PRELIMINAR PLAT
PRAIRIE RIDGE
EXHIBIT C

PLANNING REPORT

TO: Phil Kern
FROM: Alan Brixius
DATE: November 7, 2924
RE: Prairie Ridge – Townhome Sketch Plan
FILE NO: 432.07 24.10

Exhibit A

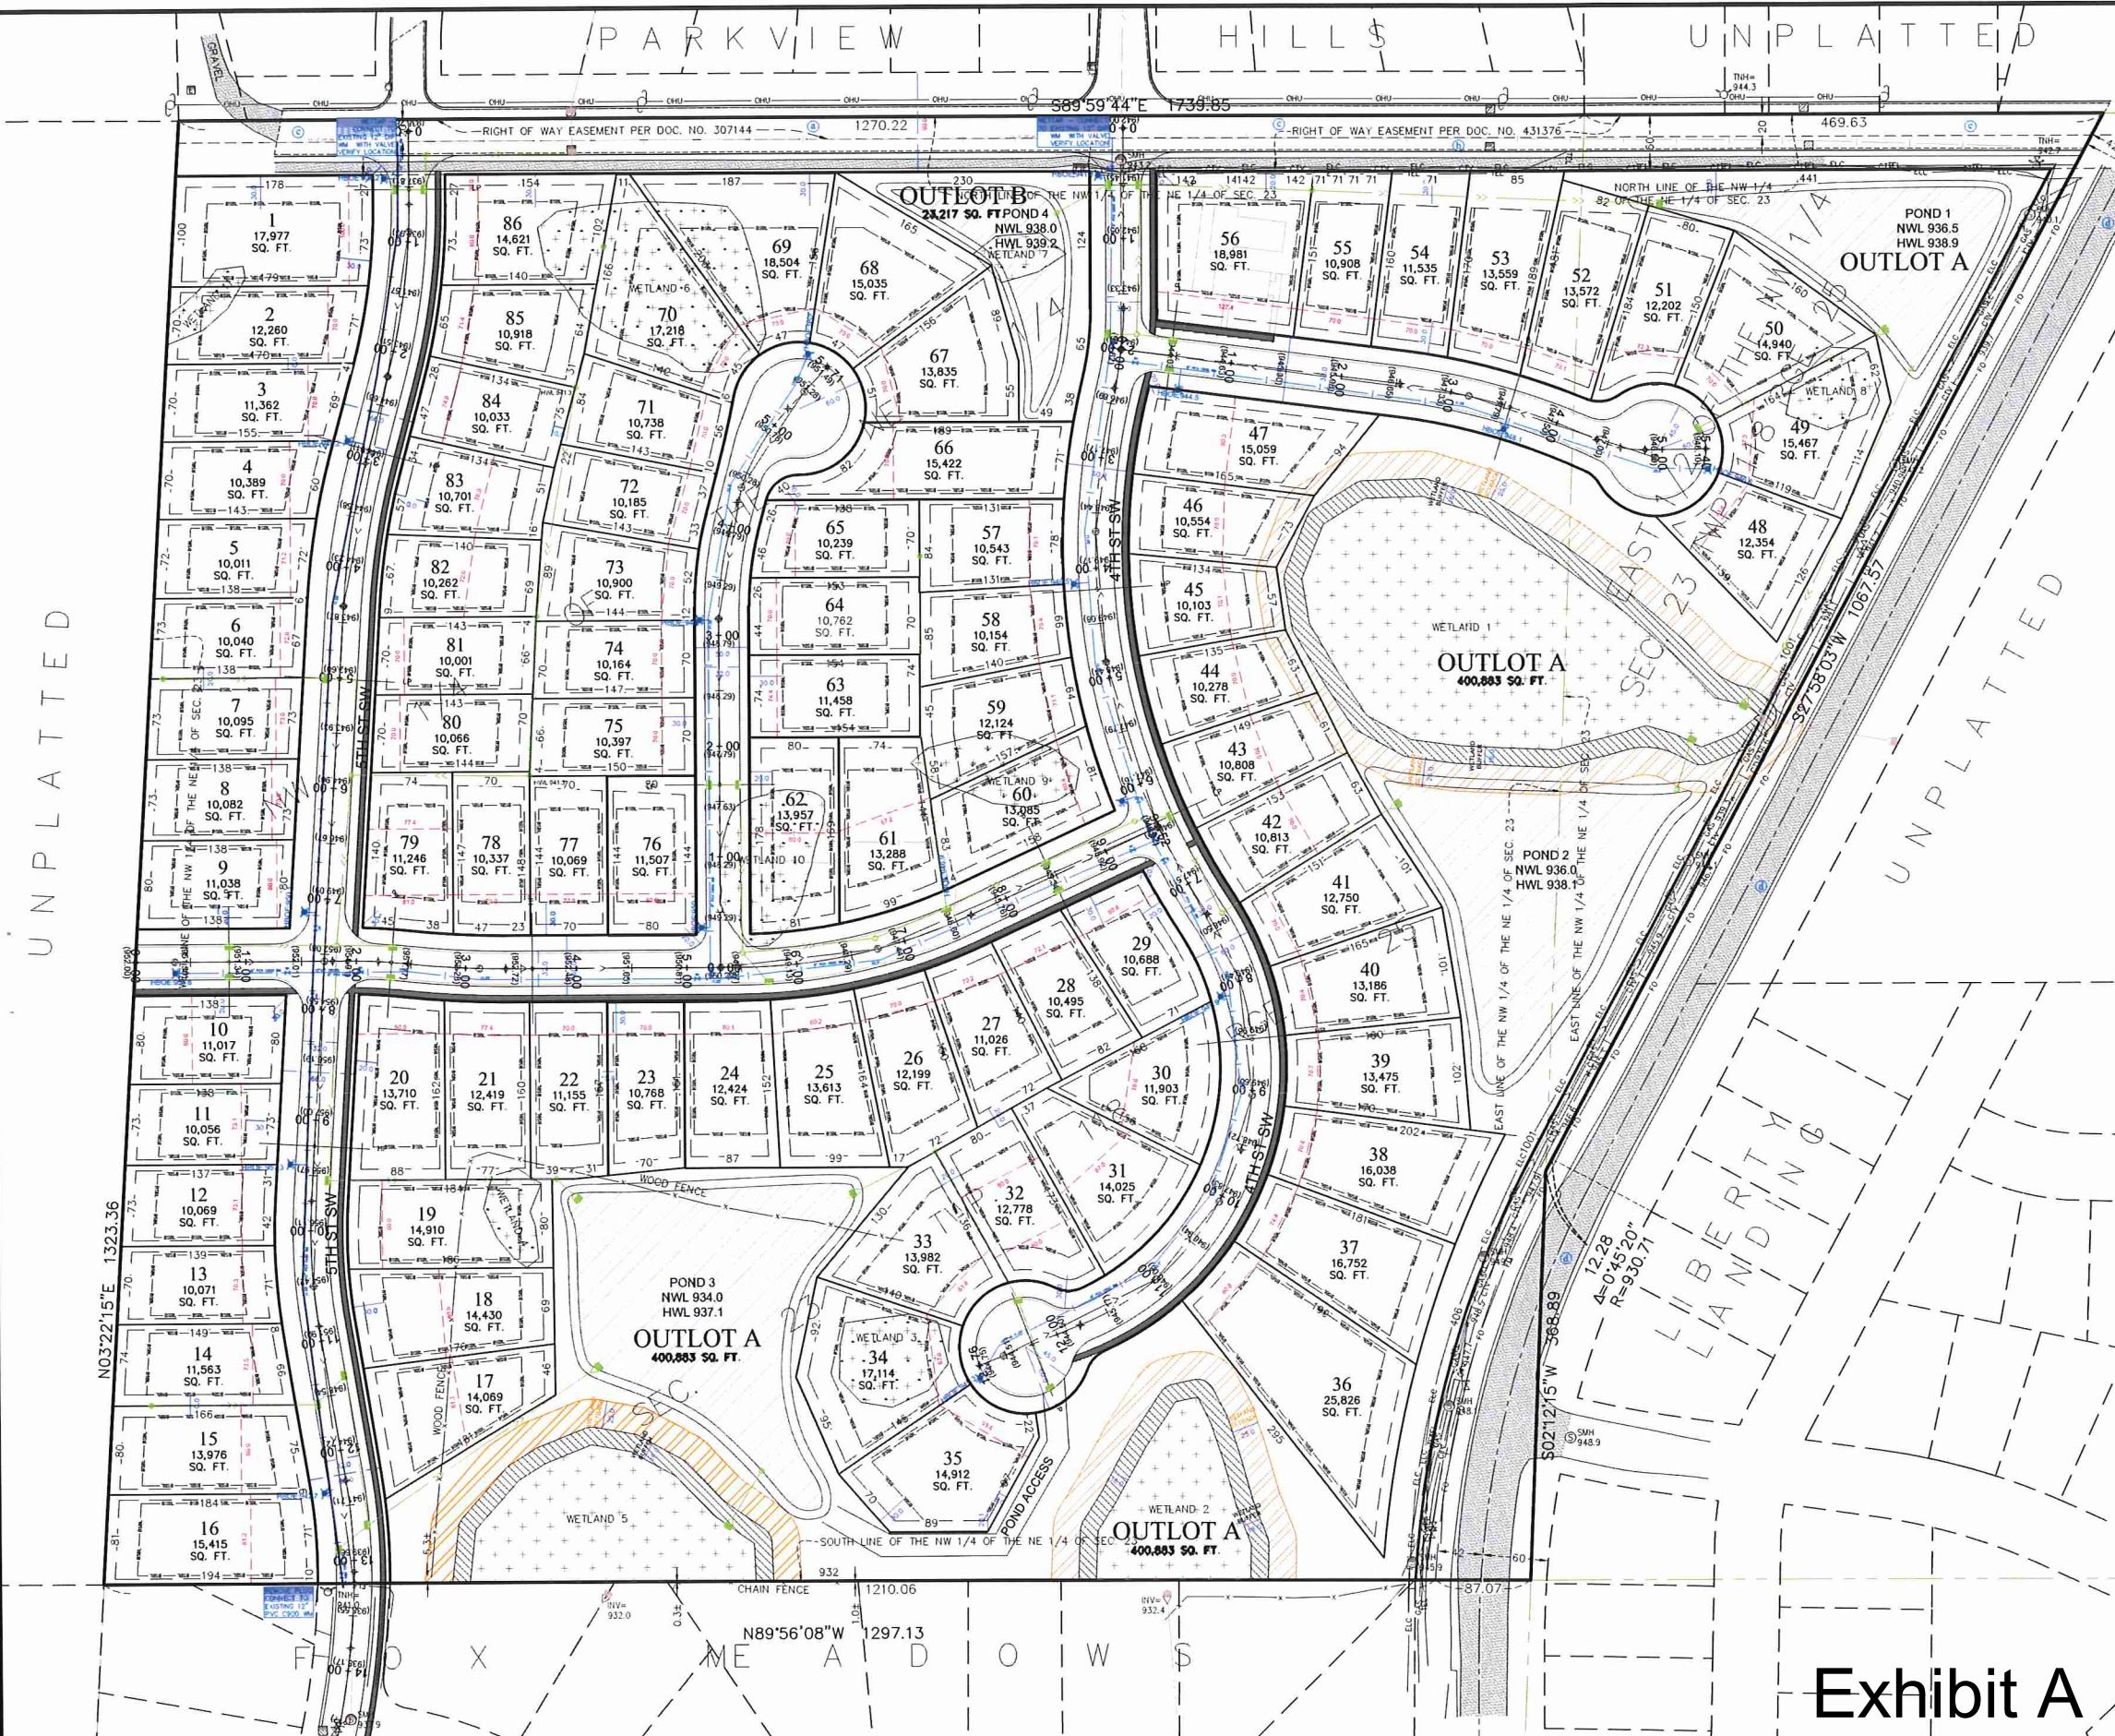
1. All the interior lots meet or exceed the R-3 district minimum lot area and width standards. R-3 district requires a lot area of 10,500 sq. ft. and lot width of 70 feet.

2. Corner lots 9, 10, 29, 76, 79 fall below the R-3 corner lot requirements of 12,000 sq. ft. of lot area and 90 feet of lot width. Corner lots 20, 47, 60, 62 fall below the R-3 corner lot width requirement of 90 feet. The city approved PUD lot width flexibility to allow for a narrower corner lot width of 80 feet and reduced street side setback for these lots.

3. Lots along the periphery of the site, which border Fox Meadow to south must be designed to meet the minimum R-2 District lot requirements. R-2 district requires a minimum lot area of 12,500 sq. ft. and lot width of 80 feet.

4. Lots must meet the district lot area standards with buildable land exclusive of wetlands and wetland buffers. Lot 2, 19, 34, 49, 50, 59, 60, 62, 69 and 70 all contain wetlands. These lots cannot be approved without a TEP approval of a wetland mitigation plan allowing these wetlands to be filled and mitigated to allow for the creation of the lots.

CONCEPT PLAN 10-22-2024

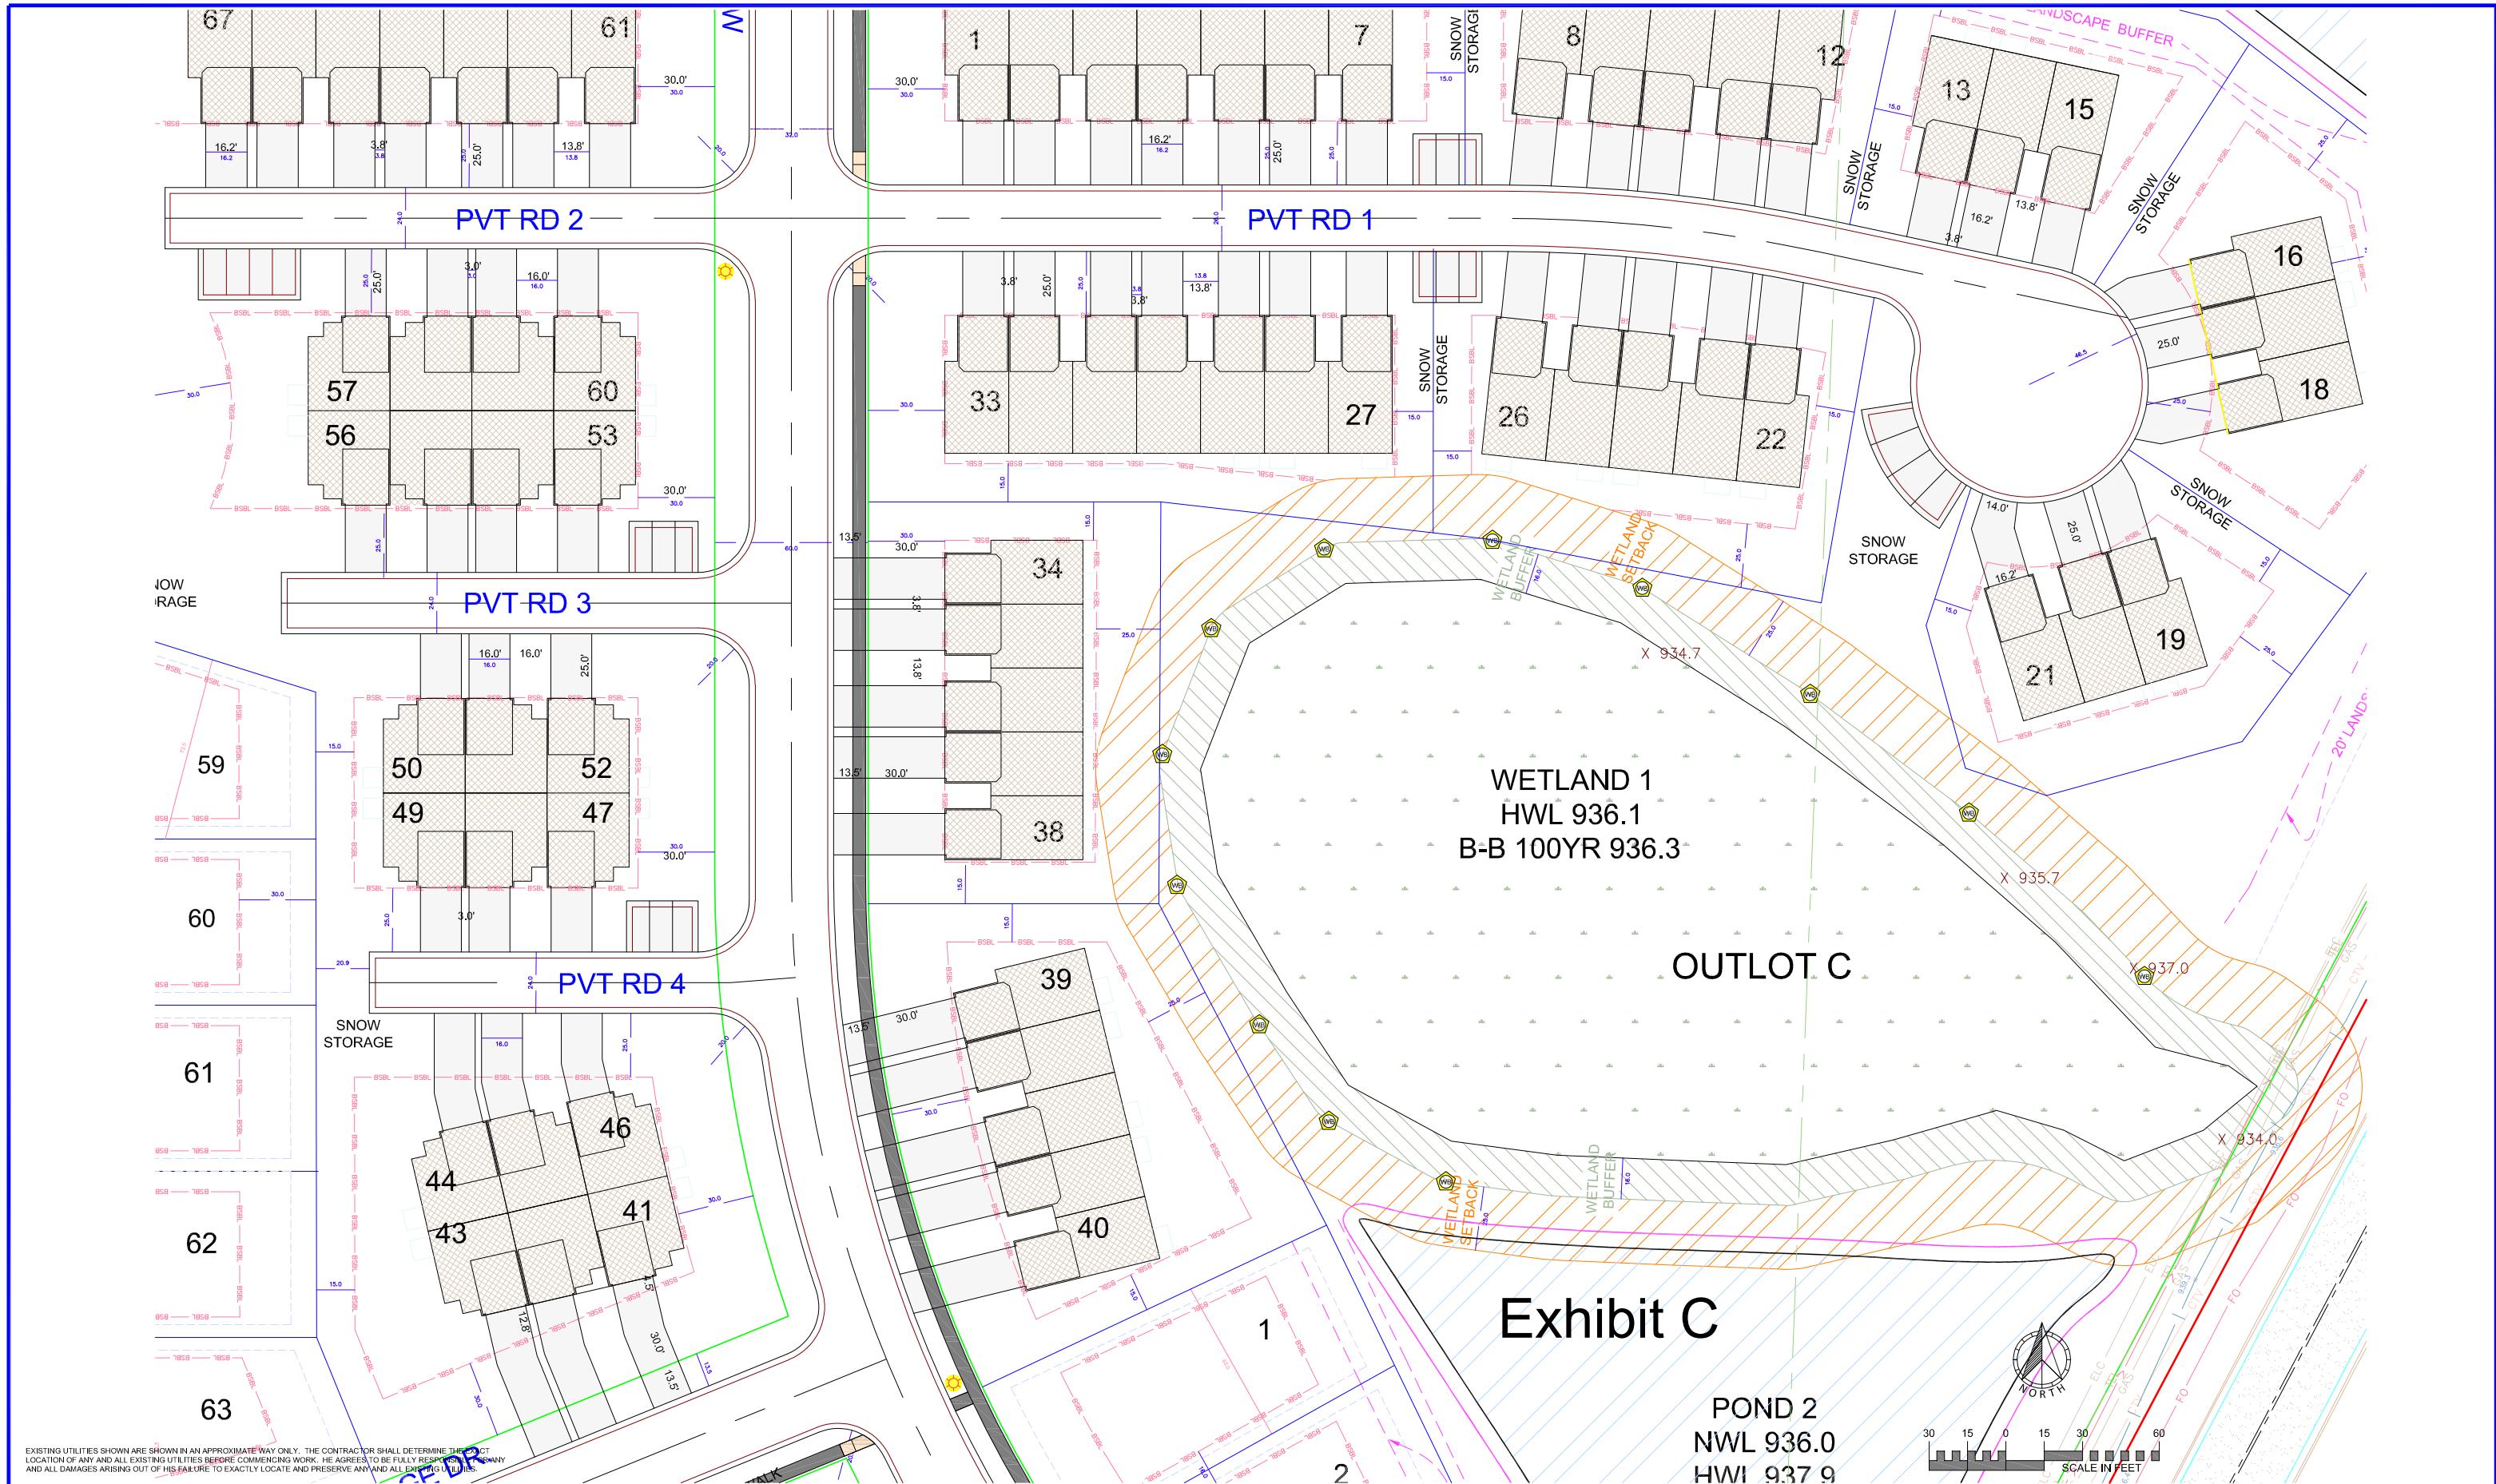
The sketch plan now proposes single family lots having lot areas of 9,000 sq. ft. and lot widths ranging from 65 to 75 feet. This is a significant change from the previously approved preliminary plat. The reduced lot sizes would require flexibility through a conditional use permit /Planned Unit Development.

In response to the inclusionary housing requirements for residential planned unit developments the sketch plan proposes 67 townhome units in the northeast corner of the plat. The 67 townhomes are 51% of the housing units within the plat. The applicant has provided plan sets for the townhome units.

1. The site plans do not show patios or decks associated with the townhomes. Details on outdoor space will need to be provided if the project progresses.
2. The building elevations show the minimum roof overhangs.
3. The building elevations for the Grandview and Westview models show a exterior combination of materials on the front of the townhomes. The front elevation appears to meet the above exterior building finish requirements above. More detailed building elevations must be provided if this project proceeds. The Birchwood and Hazelwood models appear to have less variation in exterior materials.

Comment: The townhomes will be slab on grade construction. By code dwellings without basements are required to provide a garage size of 500 sq. ft. to provide for household

storage needs. The Grandview and Westview models offer a garage size of 406 sq. ft. and the Birchwood and Hazelwood models offer a garage size of 385 sq. ft.

Applicants will be seeking PUD flexibility for garages smaller than the City standard. In pursuing this flexibility, the Applicant must demonstrate that the proposed garage size is sufficient to address need garage storage (two cars, bicycles, trash and recycling equipment and other ancillary household equipment). The applicant must provide a garage diagram showing the garage storage uses fitting into the proposed space. The floor plans must demonstrate interior storage areas to compensate for the reduced garage size.

The Townhome development will be served by four private streets, having width ranging in width from 24 to 26 feet. These streets shall be posted no parking. These streets will be owned and maintained by the Townhome HOA. With the reduced street width, high number of driveways, and minimum boulevard, the Applicant has identified locations for snow storage.

The number and spacing of the townhome driveways on the private drives raises concern for site access, utility services, snow storage and landscaping. In this regard, the following standards will be considered if this project proceeds to preliminary plat.

1. PUD restriction on driveway widths for the townhome units.
2. Protection of the spaces between the townhome driveways.
3. Front yard landscaping.
4. Location and design of utility services to individual townhome units.

1. The planning commission was comfortable with the introduction of townhomes into the subdivision to accomplish the inclusionary housing objectives of the City.

2. The location of the townhomes and the setback flexibility is seen as reasonable.
3. The reduced lot areas and lot widths for the single family lots should either be the same as the original preliminary plat or the developer demonstrate that proposed houses will be sized to be appropriate for the given lots. Avoid large homes that overwhelming small lots.

5. The Planning Commission is open to allowing some building design flexibility with the townhomes to achieve the inclusionary housing values.

The Planning Commission recommended that JP Brooks proceed to submit development applications for a zoning map amendment to allow townhomes, conditional use permit/planned unit development, and new preliminary plat. The new submissions will be required to address the aforementioned Planning Commission concerns.
